CONSTRUCTION PLANS FOR CARRIAGE MEADOWS SOUTH AT LORSON RANCH

STREET, STORM SEWER, AND POND CONSTRUCTION PLANS

COVER SHEET
STREET, STORM SEWER AND POND
CONSTRUCTION PLANS

**TYPICAL SECTION 50' R.O.W.
RESIDENTIAL URBAN LOCAL**
NOT TO SCALE

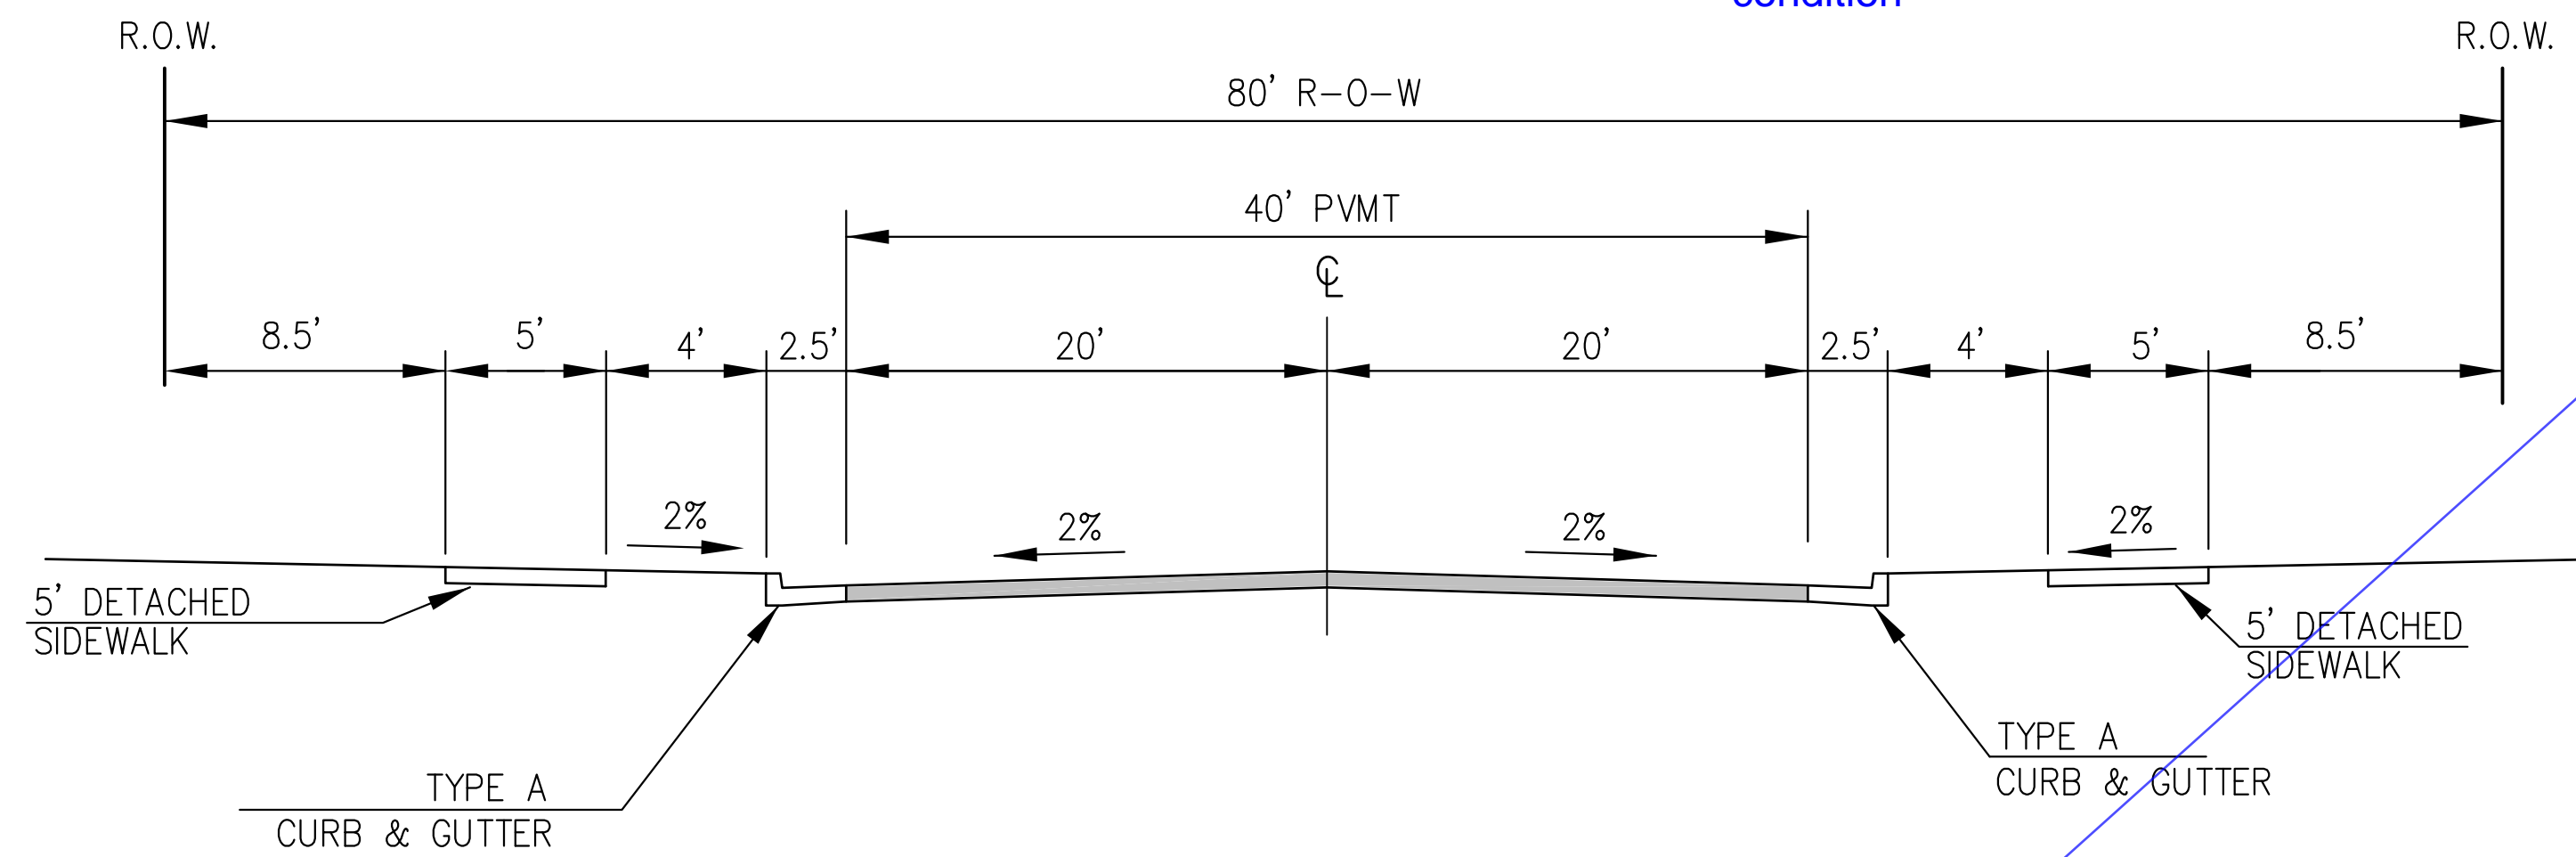
for better
performance,
please use
EPC optional
type C curb
and gutter per
SD 2-20.

please show
the anticipated
'ultimate'
condition

**TYPICAL SECTION 80' R.O.W.
RESIDENTIAL URBAN COLLECTOR**
NOT TO SCALE

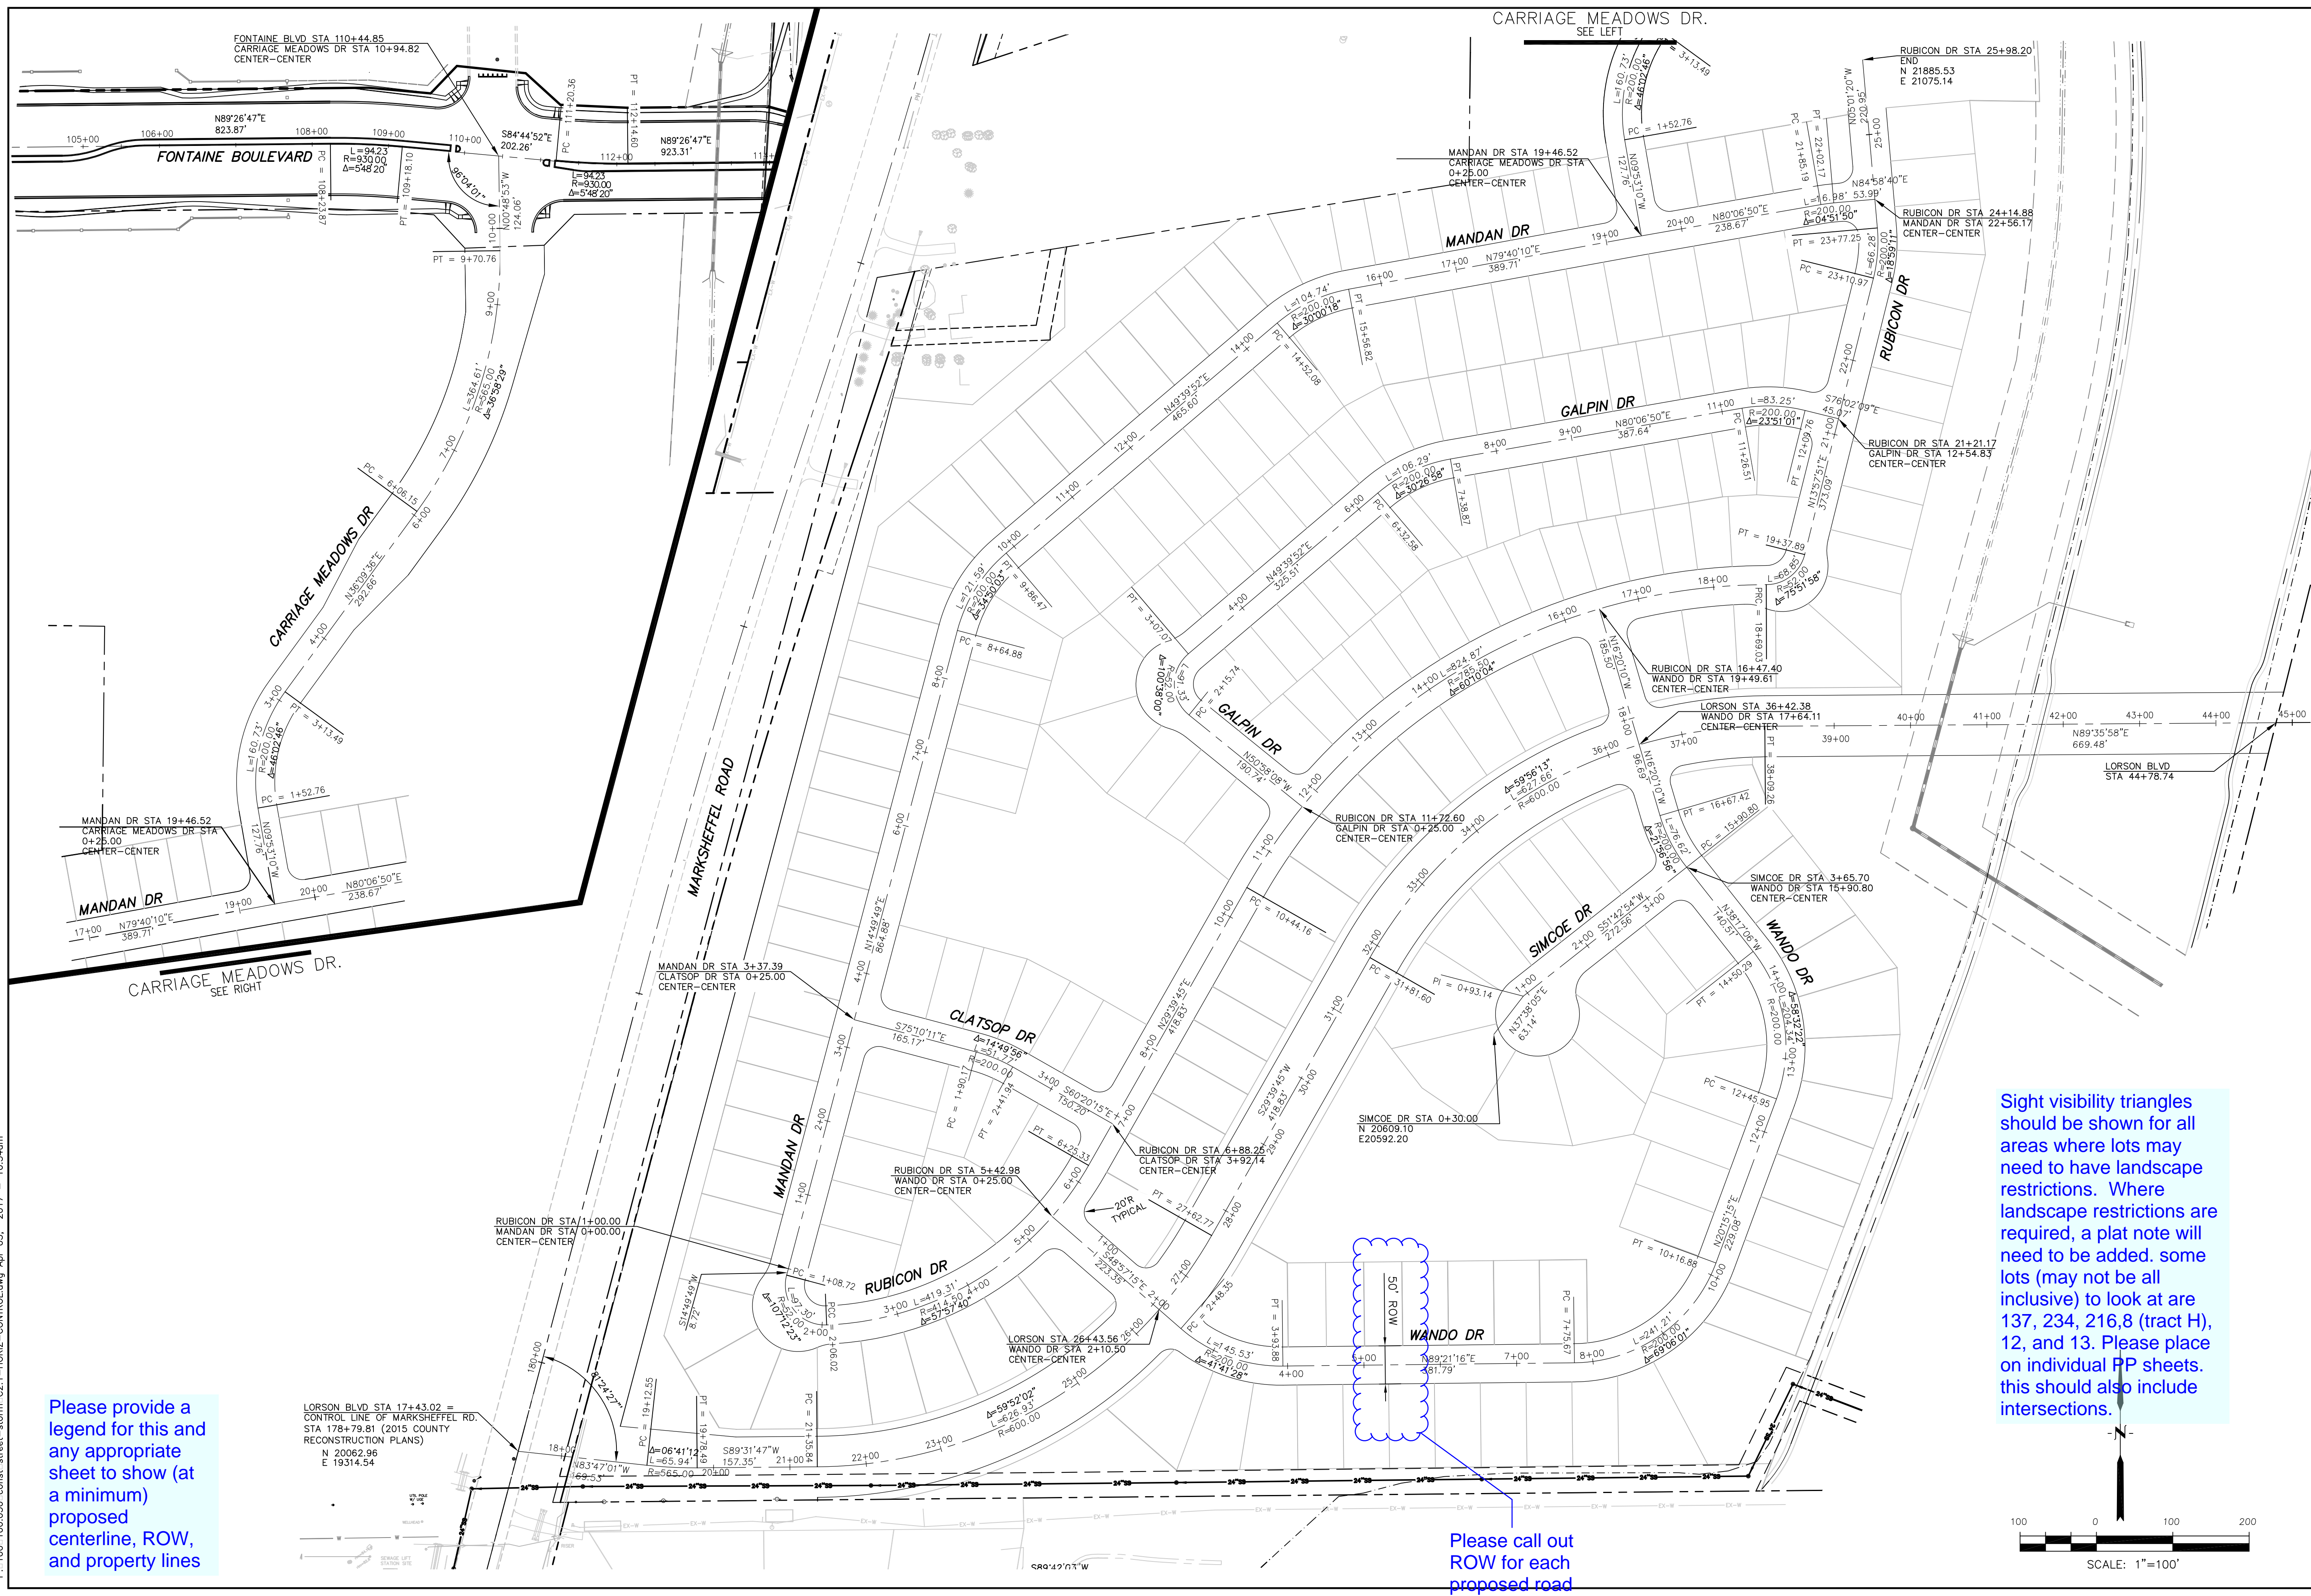
Please show cross section of Carriage
Meadows Drive just before the intersection
with Fontaine.

Please add
posted speed
and design
speed to this
document.

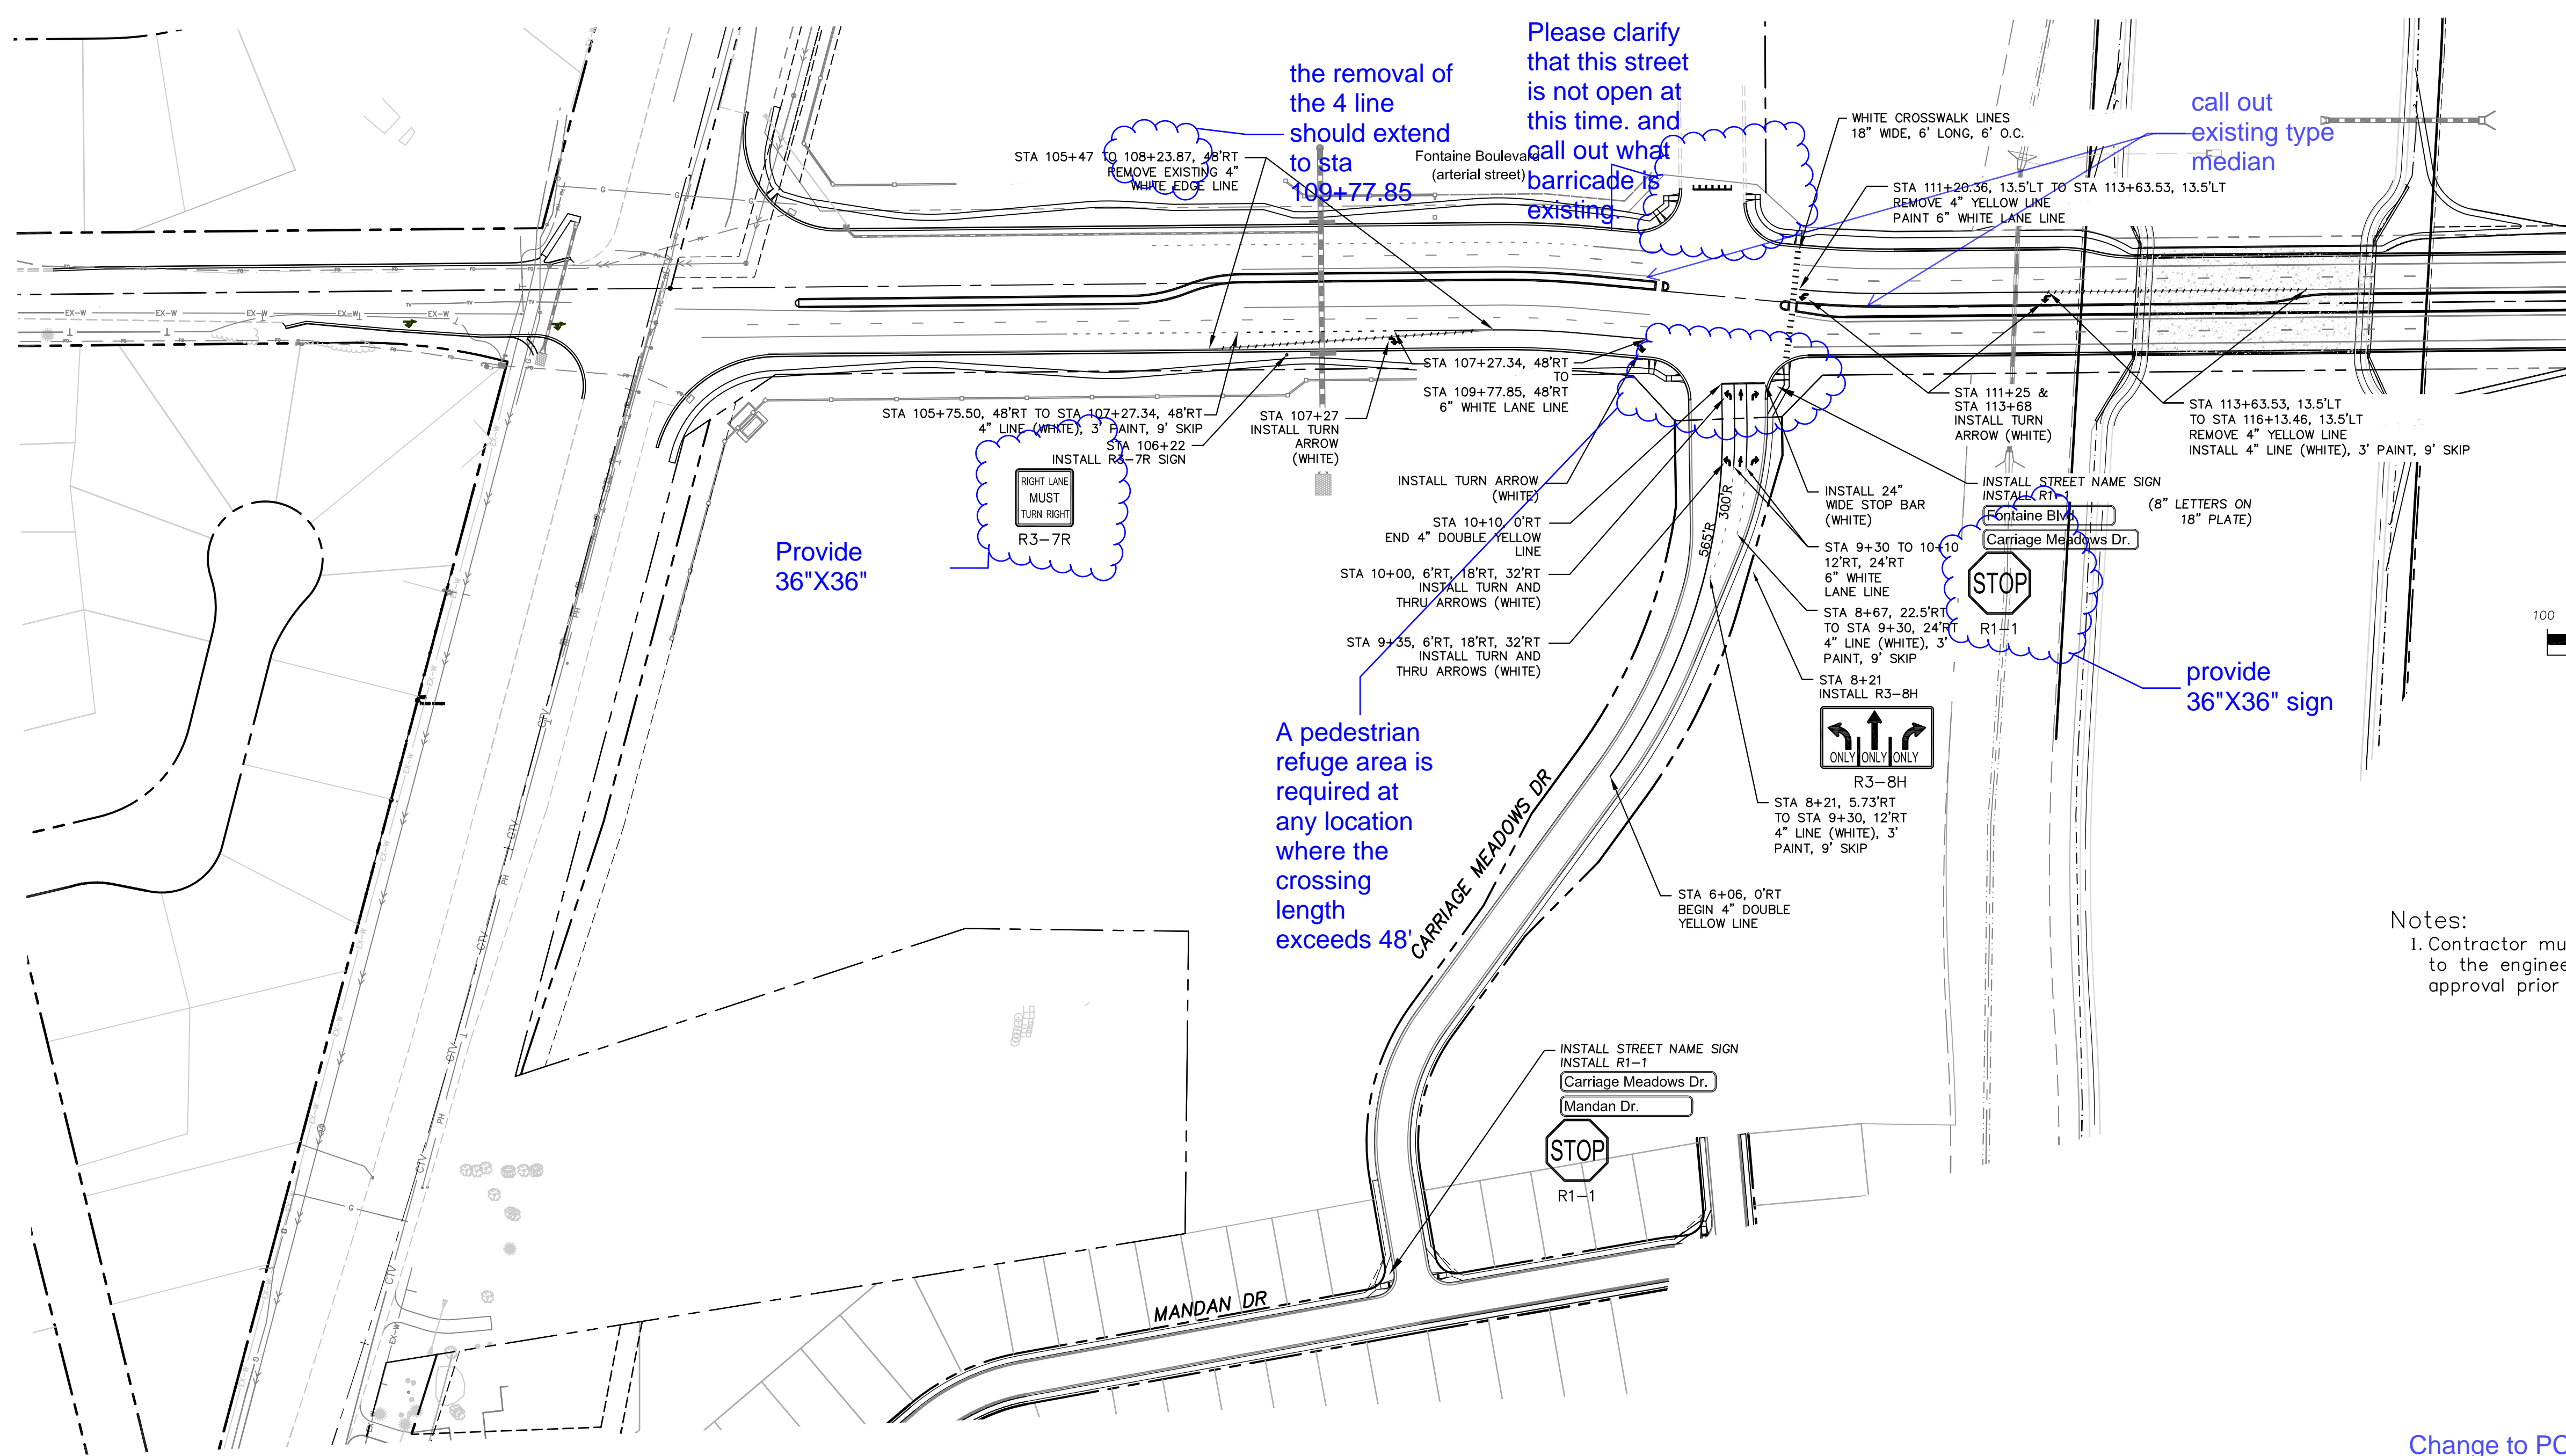
Please provide a legend for this and any appropriate sheet to show (at a minimum) proposed centerline, ROW, and property lines

Sight visibility triangles should be shown for all areas where lots may need to have landscape restrictions. Where landscape restrictions are required, a plat note will need to be added. some lots (may not be all inclusive) to look at are 137, 234, 216,8 (tract H), 12, and 13. Please place on individual PP sheets. this should also include intersections.
